PARACHUTES DE FRANCE 2 rue Denis Papin Jouy le Moutier 95031 Cergy Pontoise Tél. 33 1 34 32 77 77 Fax 33 1 34 32 73 17	<h2>Service Bulletin</h2> <p>Title : Evolution of the TECHNO 240-B</p>	IGQ_MNG_MQL_004_ENR01 Version 1 du 17/01/06 BSV_06_001 Date: 08/06/06 Page 1/4
--	--	--

Block 1	<u>Technical Background</u>	
a)	Applicability	: All TECHNO 240-B. Part Number : R01-240-B.
b)	Reason	: During dummy tests, a slow deployment of a TECHNO 240-B has been detected.

c)	Description	: Slider and main steering lines replacement, packing modification
d)	Compliance	: Mandatory before any use of a TECHNO 240-B.
e)	Approval	: The technical data have been approved by Parachutes de France in accordance with § 21A.611 of the regulation Part 21.
<p>The implementation of this Service Bulletin is made compulsory by the Airworthiness Directive No 2006-0160-E from EASA</p>

STEP A - STEERING LINES REPLACEMENT:

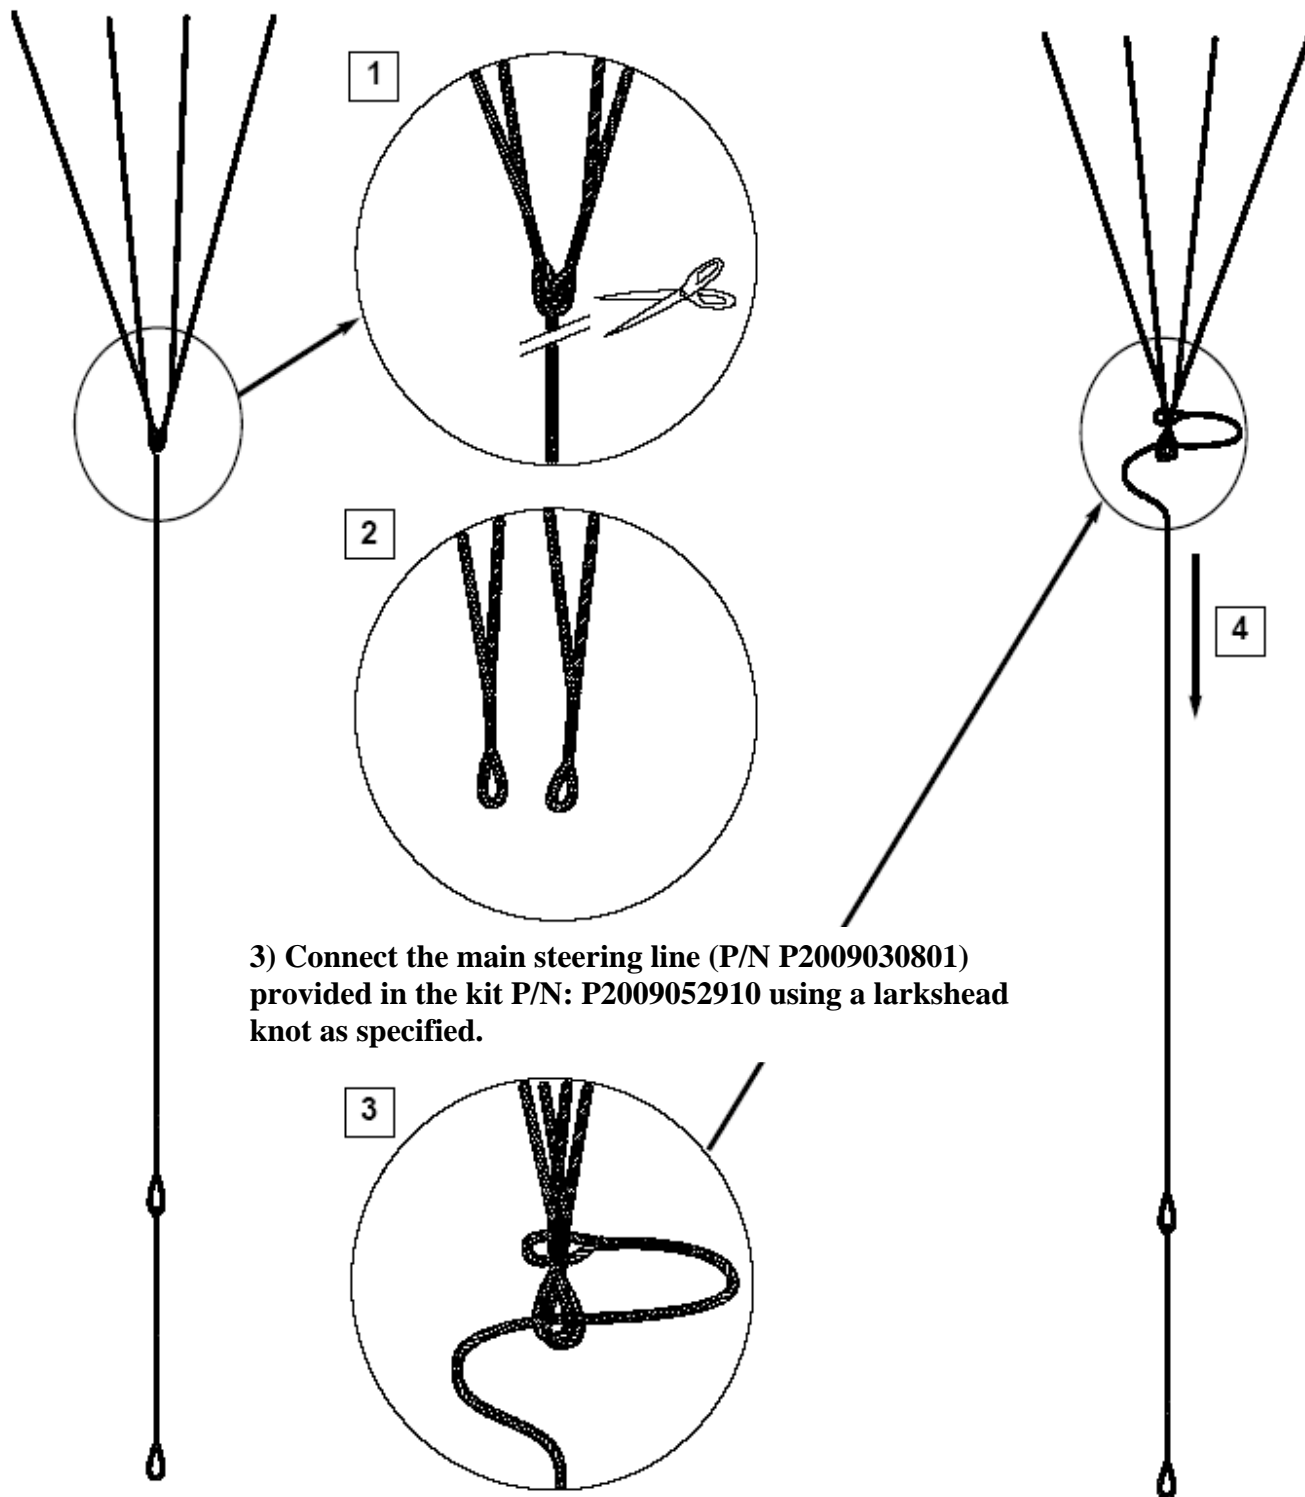
1) and 2) Cut the steering line of canopy at the specified point to remove main steering line from secondary

3) Connect the main steering line (P/N P2009030801) provided in the kit P/N: P2009052910 using a larkshead knot as specified.

4) Hold the larkshead knot tight.
Carry out same operations to the opposite steering line.

Front lines assembling

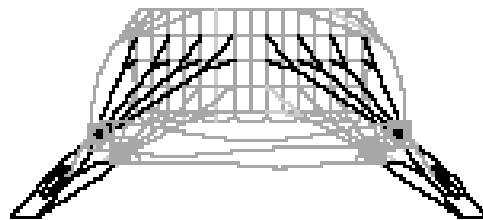
- 2) Connect the canopy to the rig.
- 3) Check the canopy connection to risers with the following drawing:
